**Standardization of technical and safety requirements in inland navigation:
Recommendations on Harmonized Europe-Wide Technical Requirements
for Inland Navigation Vessels (resolution No. 61, revision 2)**

Amendments to the annex to Resolution No. 61 on Recommendations on Harmonized Europe-Wide Technical Requirements for Inland Navigation Vessels, revision 2

Note by the secretariat

Figure 10A-1

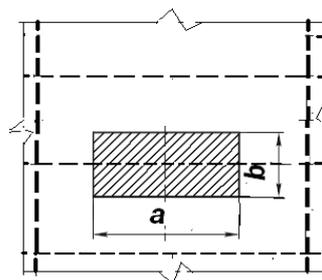
The design position of the wheel footprint for the purpose of calculating the strength of the plate is shown in figure 10A-1 and the strength of the stiffener in 10A-2.

Dimensions of the loading platform, [m], when vehicles move along the beam framing (see figs. 10A-1 and 10A-2) are determined by formulas:

$$a = \sqrt{kA},$$

$$b = \sqrt{A/k},$$

Where

a is the length of wheel footprint (along the vehicle), [m];

b is the width of the wheel footprint (across the vehicle), [m];

k is a factor and is taken to equal:

- A single wheel 2.0
- Twin wheels 0.8
- Triple wheels 0.5.
